Z-50
(2016)

GEORGIA 811
CONCEPTUAL SITE PLAN FOR
HOPKINS ROAD

PETITION NO: Z-50

PETITION FOR: RSL

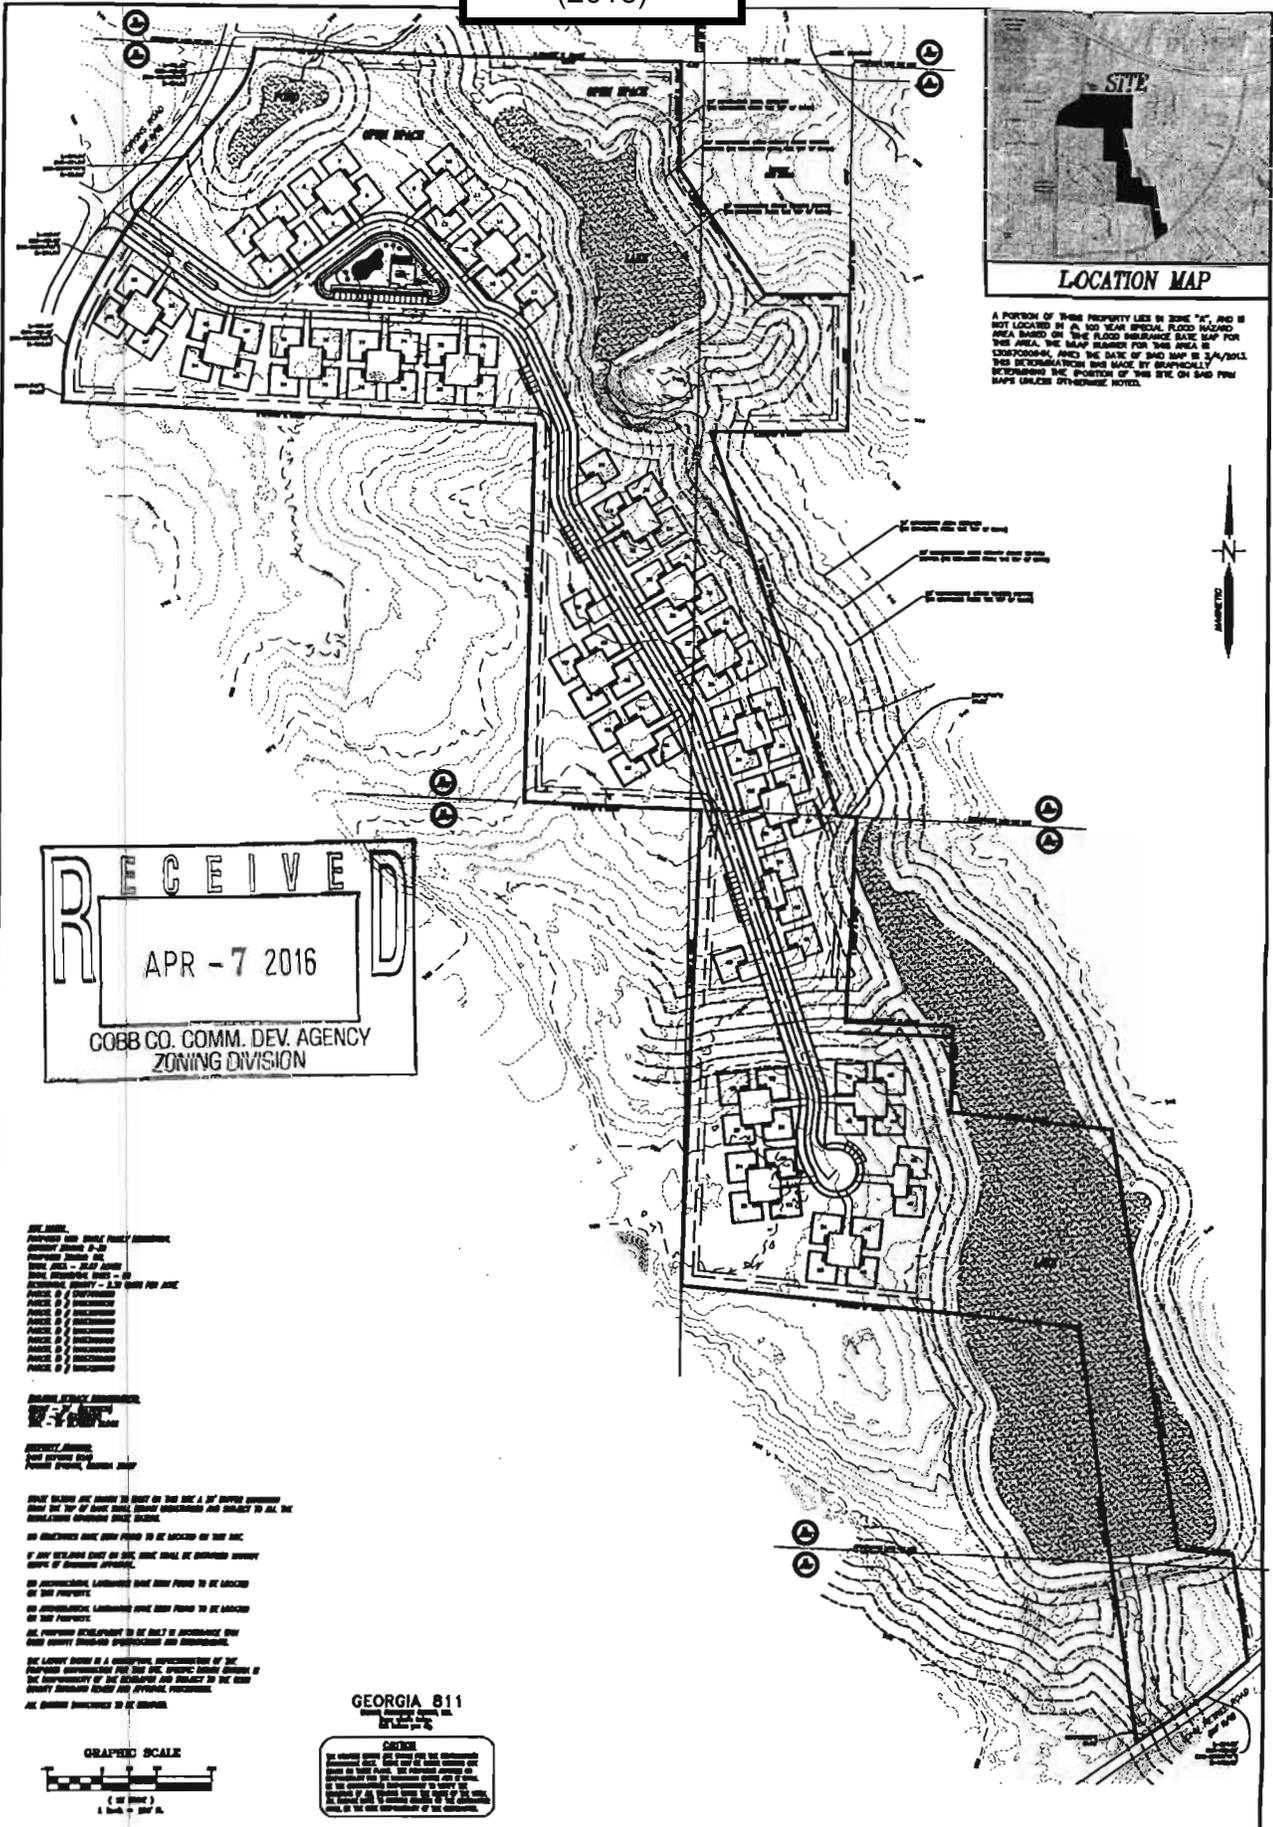
Driveways between units are required to be 20-ft to provide access to units distal to roadway.

- FEMA Designated 100 year Floodplain Flood.
- Flood Damage Prevention Ordinance DESIGNATED FLOOD HAZARD.
- Project subject to the Cobb County Flood Damage Prevention Ordinance Requirements.
- Dam Breach zone from upstream & onsite lakes - need to keep residential buildings out of hazard.

- Provide comprehensive hydrology/stormwater controls to include development of out parcels.
- Submit all proposed site improvements to Plan Review.
- Any **spring activity** uncovered must be addressed by a qualified geotechnical engineer (PE).
- Structural fill _____ must be placed under the direction of a qualified registered Georgia geotechnical engineer (PE).
- Existing facility.
- Project must comply with the Water Quality requirements of the CWA-NPDES-NPS Permit and County Water Quality Ordinance.
- Water Quality/Quantity contributions of the existing lake/pond on site must be continued as baseline conditions into proposed project.
- Calculate and provide % impervious of project site.
- Revisit design; reduce pavement area to reduce runoff and pollution.

- No Stormwater controls shown _____
- Copy of survey is not current – Additional comments may be forthcoming when current site conditions are exposed.
- No site improvements showing on exhibit.

1. This parcel is located adjacent to an unnamed tributary to Noses Creek. The site includes two existing lakes and a portion of a third lake located just upstream of John Petree Road. Although not indicated on the site plan the floodplain is contained within the stream buffer.

2. Stormwater management for the site is proposed to be provided within the onsite lakes. An additional stormwater facility may be required for the southern portion of the site. The existing dams will be required to be brought up to current County standards. The stormwater management report must include storage routings through all three onsite lakes as well as dam breach analyses to verify that all structures are located outside the breach zone.
